Canyon Fuel Company, LLC. Skyline Mine

RE: Supplemental Information for Task ID #3504, Winter Quarters Ventilation Facility (WQVF), Canyon Fuel Company, LLC, Skyline Mine, C/007/005,

**WINTER QUARTERS VENTILATION FACILITY  
Supplemental Information to Task #3504**

**SUPPLEMENTAL INFORMATION**  
**TASK #3504**

Figure: 4.9-B  
 Winter Quarters Ventilation Facility  
 Vent/Escapes Shaft

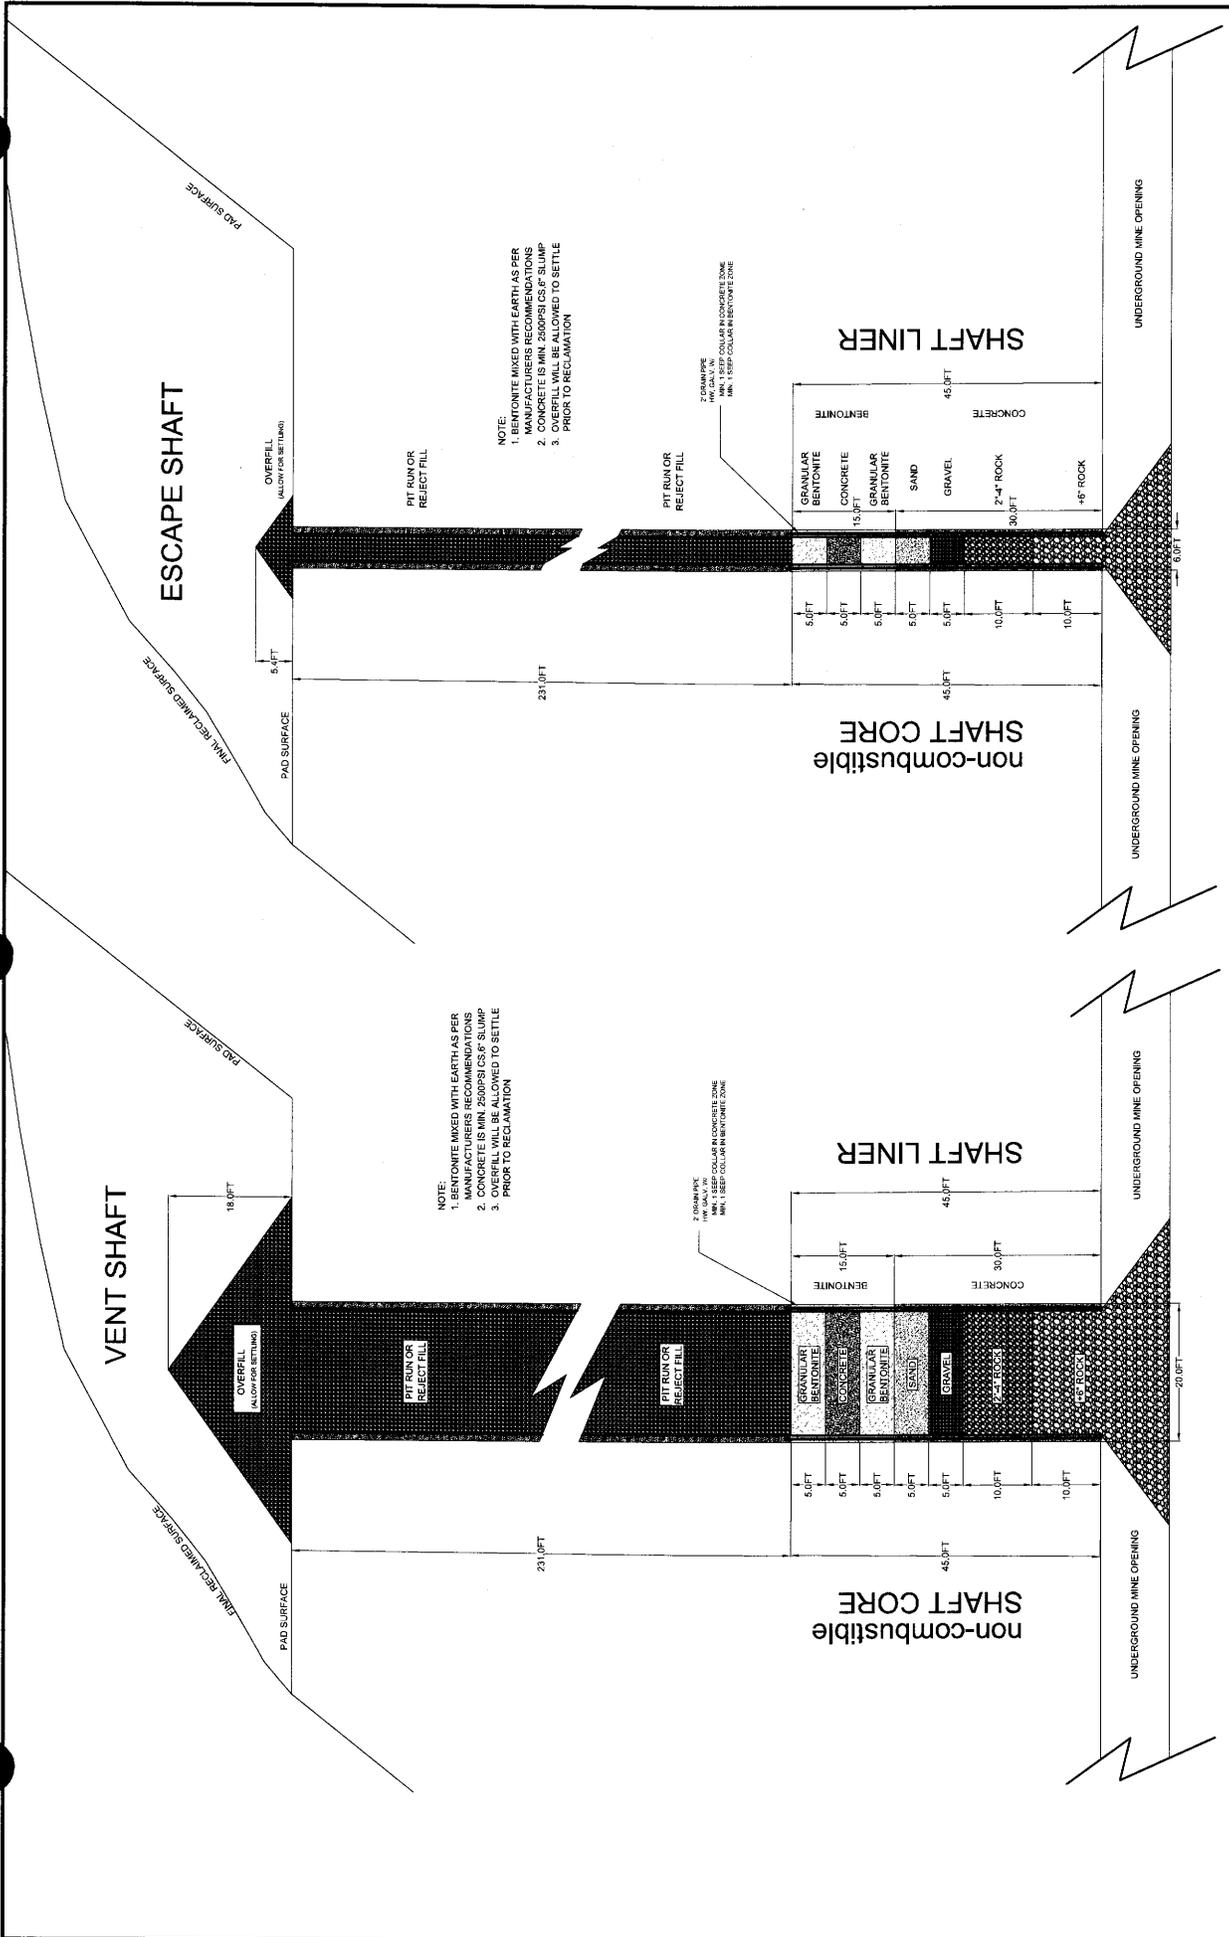
4. **(R645-301-512)** Within the submittal, the applicant included a schematic cross section of the ventilation shaft as well as a schematic cross section of the mine slope. The schematic depicts the designs for shaft backfill. Neither of the cross sections (Figures 4.9B, 4.9C) appears to have been certified by a qualified registered professional engineer, and there does not appear to be any drawings or cross sections of the escape shaft. There is not enough information provided in terms of drawings, plans, cross sections, etc. of the shafts and slopes to be considered adequate. For purposes of completeness, the applicant should provide a certified map (rather than just a schematic figure within the text) that includes all relevant details pertaining to both shafts and the slope. The map should be complete enough to be certified by a professional engineer. Depictions of the shaft should be split or otherwise presented as to allow for the drawings to be scaled. The applicant stated, "Appropriate maps will be certified when the

application is approved and clean copies are provided”. The maps depicting the shafts and slope are not yet complete enough to warrant approval.

*Figure 4.9B has been modified to include both a vent and escape shaft (separately). Figure 4.9C was modified to include a height on the entry.*

*All drawings requiring PE certification will be certified when clean copies are submitted (at Conditional Approval).*

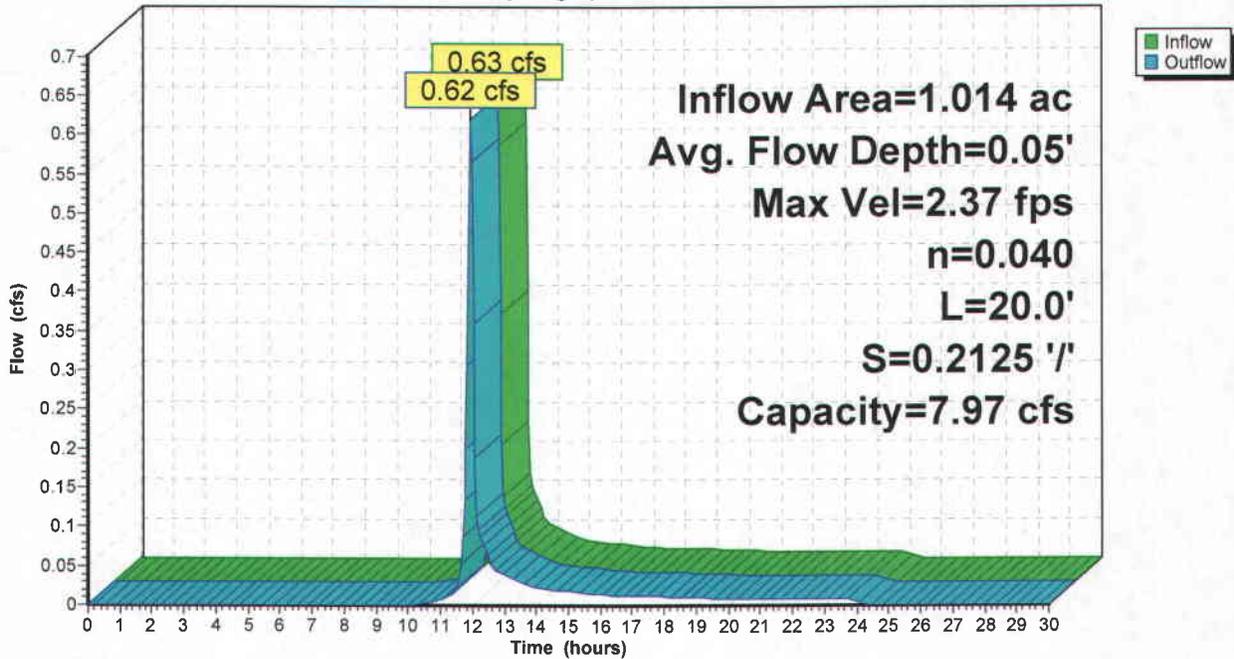
5. **R645-3012-731.600, -742.111, -112, and 113,** It is unlikely that simply allowing the water to follow the roughly 150-foot long “natural” path from the riprap pad at the outfall of the ASCA 39 culvert, across the road and along the topsoil pile berm to the stream will prevent additional contributions of sediment to Winter Quarters Creek or minimize erosion.

The Division finds that operation of the WQVF as shown on the submitted plans is likely to cause or contribute to the violation of applicable water quality standards and may adversely affect the water quantity and quality or other environmental resources of Winter Quarters Creek. Before the Division can authorize coal mining and reclamation operations at the WQVF, the Permittee must finish the runoff control design and provide a plan to control the flow over the approximately 150-foot path between the riprap pad at the outfall from the ASCA 39 culvert and Winter Quarters Creek.

*Page 68 of 85 (10yr, 24 hr ASCA) indicates the velocity of water on the road leaving the riprap (assuming the road is improved to have a gravel surface) has a maximum velocity of 2.37 fps and an average velocity of 0.56 fps.*
